**EXPLANATION OF SIGNIFICANT DIFFERENCES
FOR THE 300-FF-2 OPERABLE UNIT RECORD OF DECISION**

May 2004

USDOE Hanford 300 Area
300-FF-2 Operable Unit
Hanford Site
Benton County, Washington

Figure 1. 300 Area Waste Site Groups Identified for Unrestricted Use Cleanup.

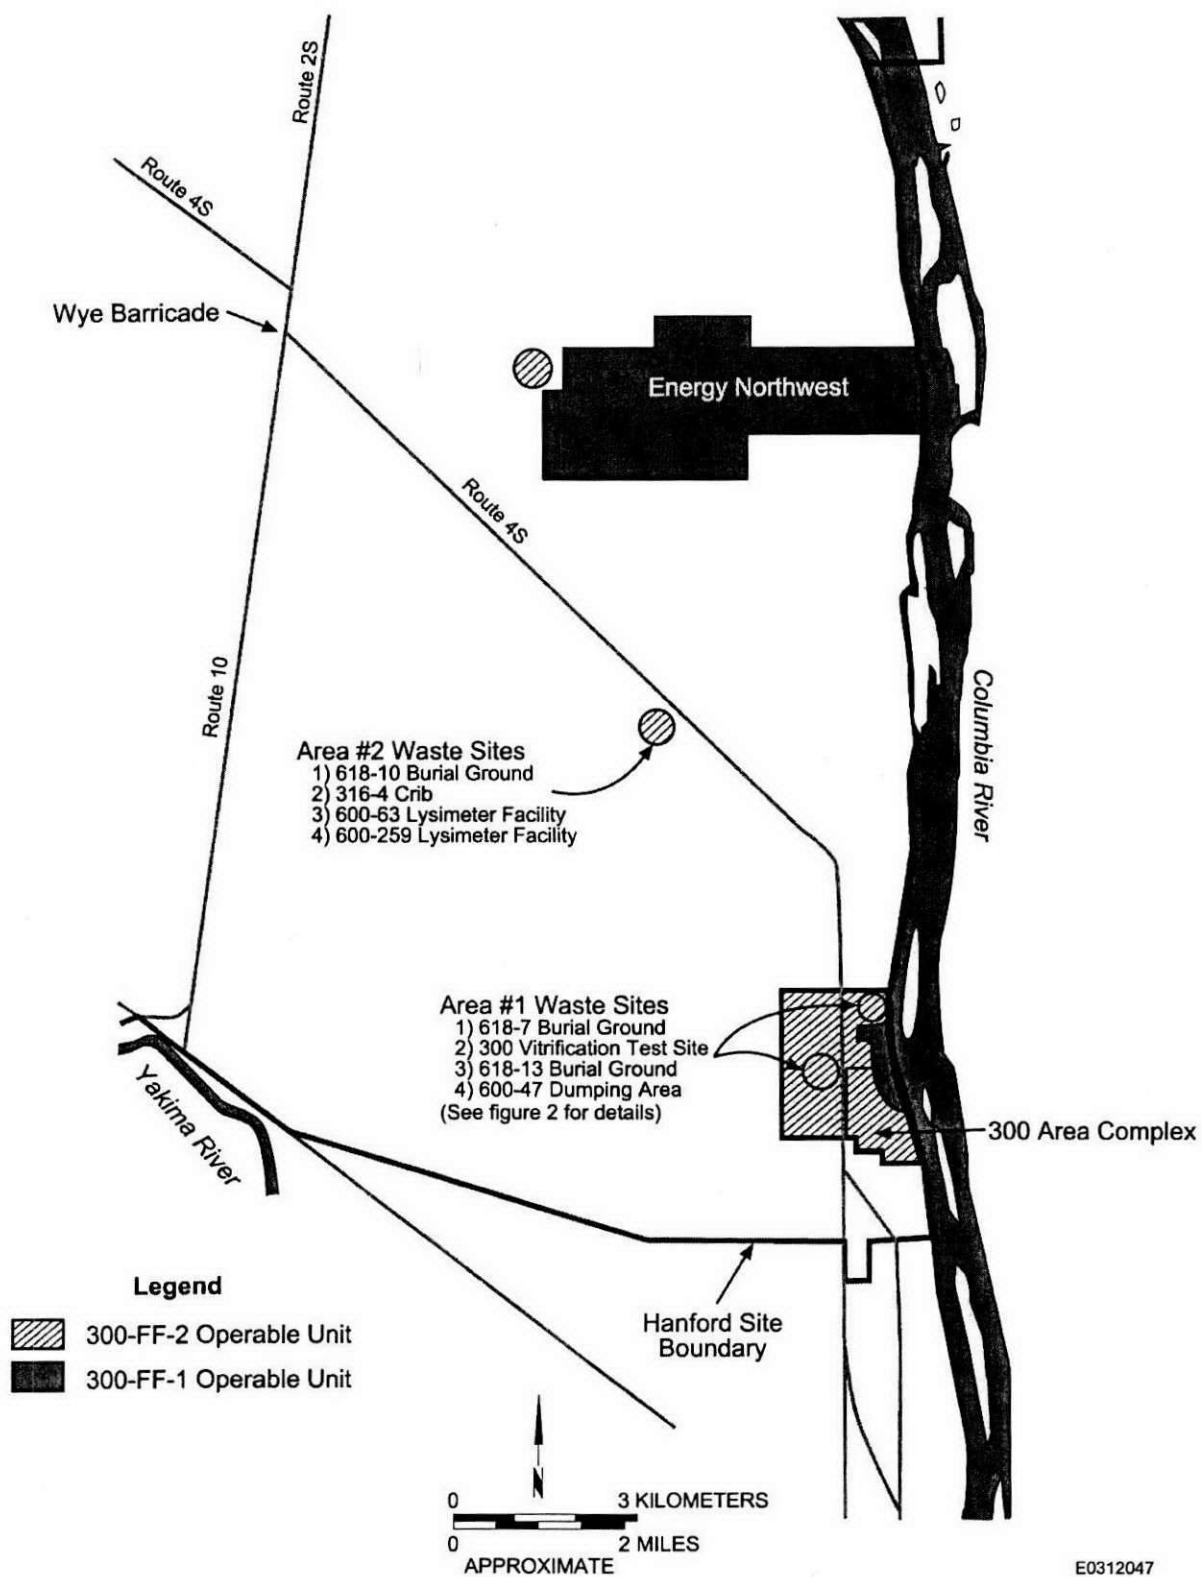
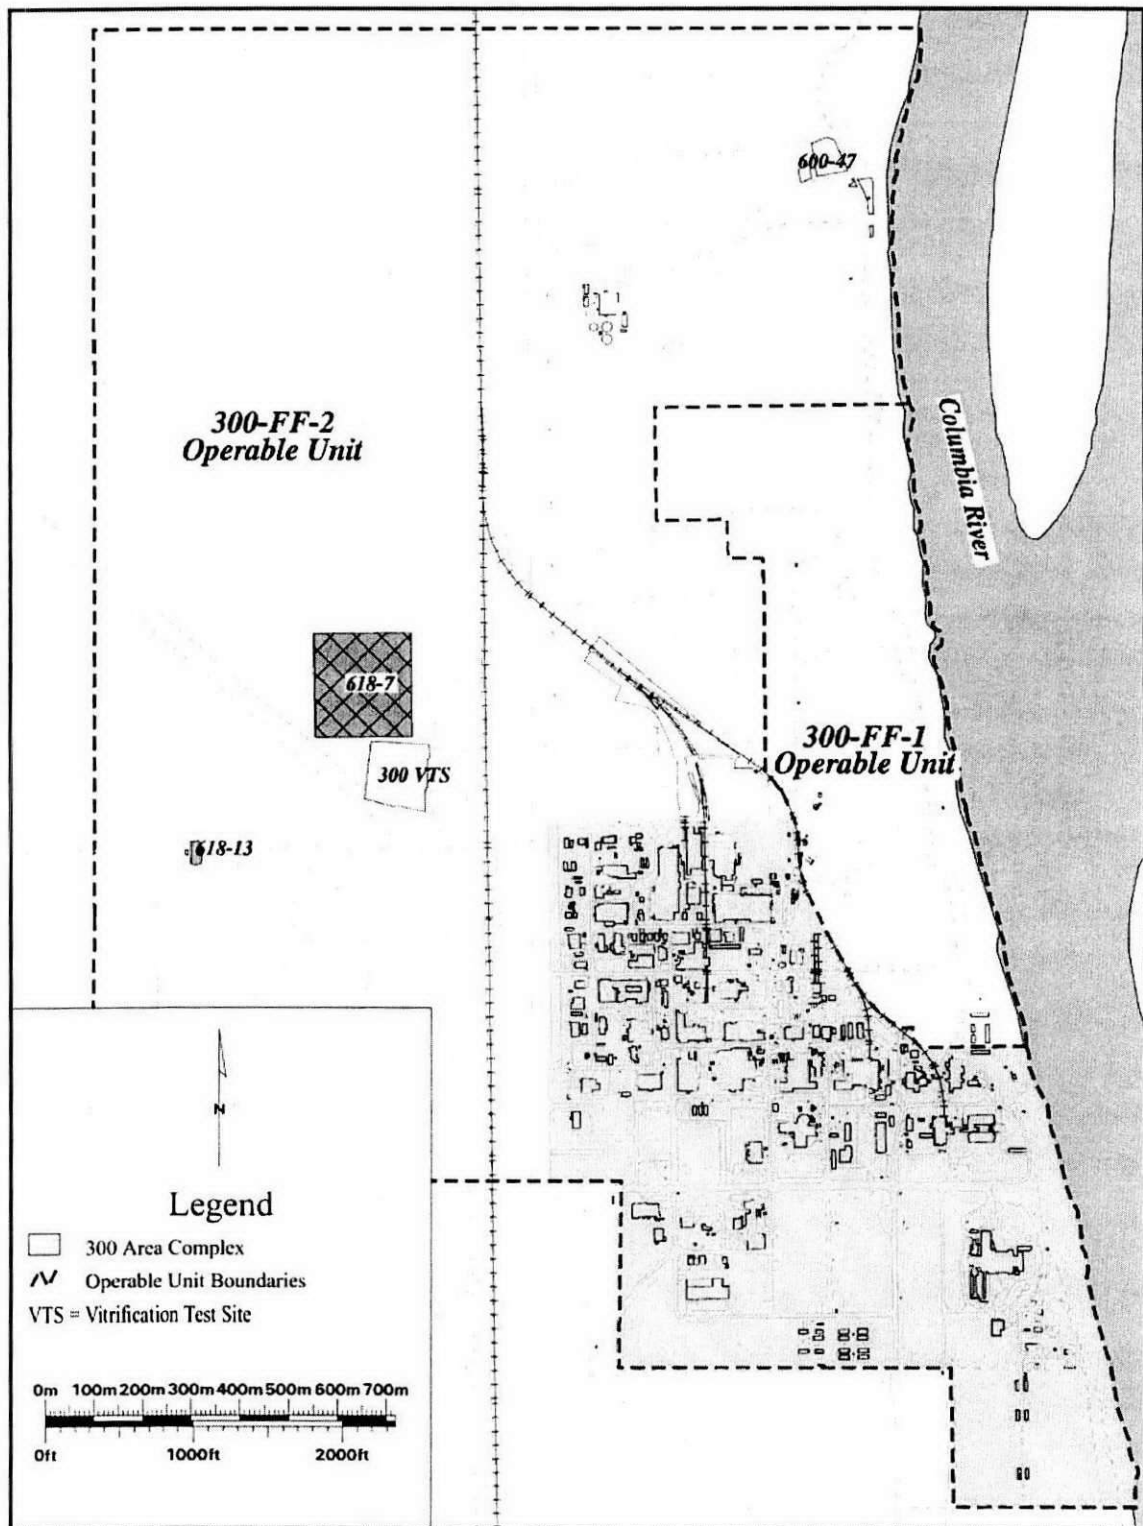
In addition, the Tri-Parties have agreed that unrestricted use soil cleanup levels for eight waste sites would be appropriate in the 300-FF-2 OU, that are located outside the 300 Area "core industrial zone area" (see Figures 1 and 2). An ESD is necessary to change the cleanup levels for these eight specific outlying waste sites.

Change 2: Modify the soil cleanup levels for eight outlying waste sites.

The key assumptions in the 300 Area unrestricted land-use scenario that affect the groundwater protection determination are irrigation at agronomic rates (76 cm/yr [30 in./yr]), surface vegetation resulting in an evapotranspiration coefficient of 91%, and the change in the exposure pathway to include drinking water ingestion. Based on the unrestricted land-use scenario described above, the cleanup levels to be used for the eight waste sites are listed in Tables 1 and 2.

Figure 3. Solid Waste Uranium Groundwater Protection Assessment Model.

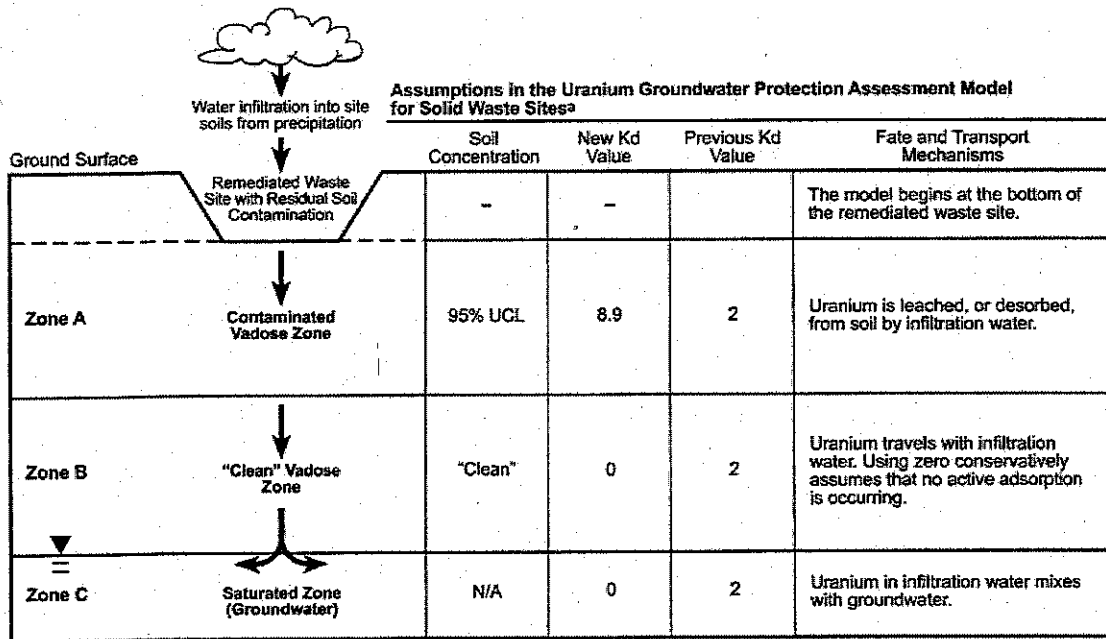
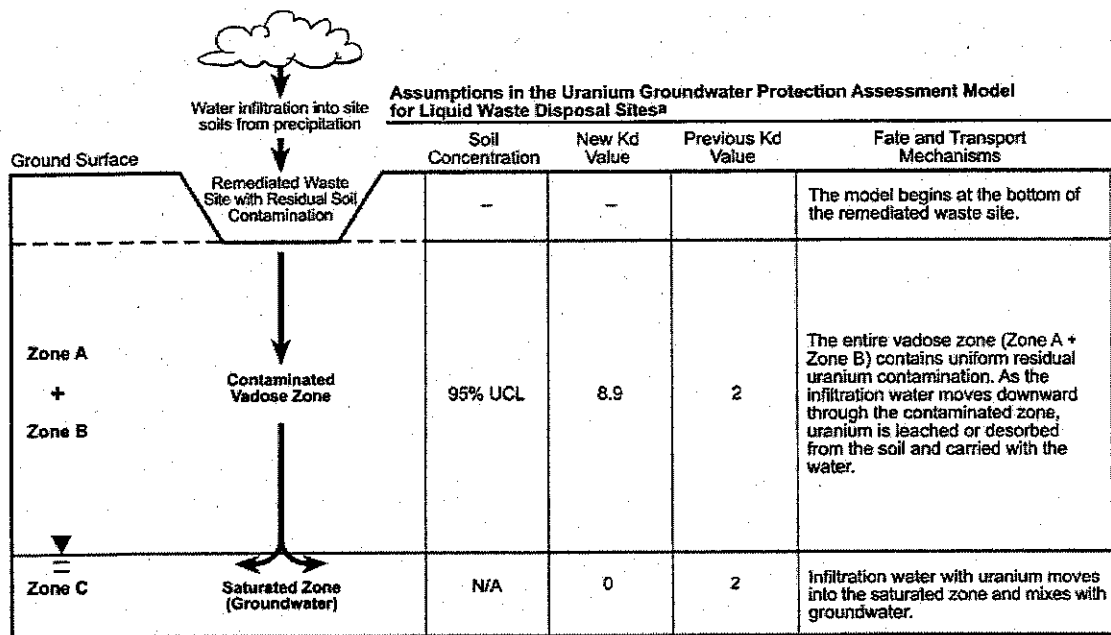
The old and the new conceptual models are shown in Figures 3 and 4.

A revision has been made to the conceptual site model (see the "Analysis of Results and Revision of Conceptual Site Model" section for a description of the old and new conceptual models), which is used to evaluate compliance with the RAOs specified in the 300-FF-2 ROD (EPA 2001) for cleanup actions to be protective of groundwater and surface water quality. The change is to use K_d values and a revised conceptual site model that is representative of the observations made during the PNNL leach test/ K_d study (PNNL 2002).

A RESRAD assessment of site-specific residual uranium soil concentrations for groundwater protection was performed using new K_d values (8.9 mL/g for the contaminated zone, 0 mL/g for the uncontaminated zone, and 0 mL/g for the saturated zone). In addition, the approaches developed in the *Remedial Design Report/Remedial Action Work Plan for the 300 Area* (RDR/RAWP) (DOE-RL 2002b) for cleanup verification of solid and liquid waste disposal sites were also applied. The RESRAD calculations used the applicable land-use scenario (industrial, without irrigation), soil characteristics, and hydrogeologic inputs. The model calculated the concentrations in groundwater, and then these concentrations were compared to the drinking water standard maximum contaminant level (MCL) of 30 $\mu\text{g/L}$ (20.8 pCi/L) for making decisions on whether residual contamination levels are protective of groundwater. The model predicts that 267 pCi/g of uranium in soil is protective of groundwater at the drinking water MCL standard and of the Columbia River.

The soil cleanup level for uranium for the 300 Area industrial waste sites will be changed from 350 pCi/g to 267 pCi/g (see Table 3). The basis for this change is RESRAD modeling to predict the residual uranium soil contamination that will not cause an exceedence of the groundwater
